SERVICE PROCEDURE

**G-09503
JUNE 2009**

**SUBJECT: SAFETY RECALL (U.S.)
CAB FEED BATTERY CABLE on certain 5500, 5600,
and 5900 models built 1/7/07 thru 5/15/08 and
equipped with feature code 008875 sealed battery
cables.**

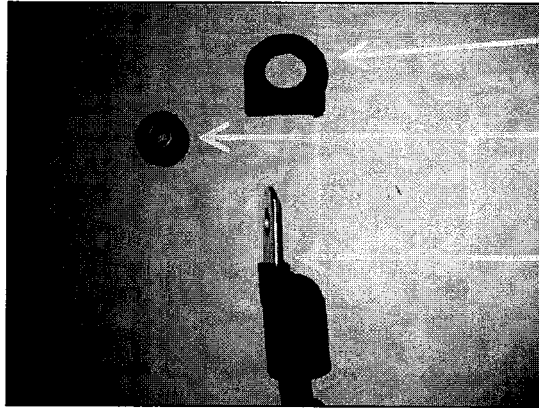
The plastic cover that seals the terminal of the cab feed battery cable may prevent proper electrical contact with the fuse or battery terminal post resulting in an open or unprotected circuit. An open circuit may result in sudden loss of cab power or engine shut down. An unprotected circuit may cause a fire in the event of a short circuit. Loss of cab power or risk of fire has the potential to cause property damage, personal injury, or death.

4. Cut and remove the end of the plastic cover of the sealed battery cable terminal. Enough of the cover should be removed to allow the block fuse to seat fully on the cable terminal. Retain the insulator nut. Discard the plastic end.

Discard Plastic End

Retain Insulator Nut

Cut back far enough for
block fuse to fully seat
on terminal.
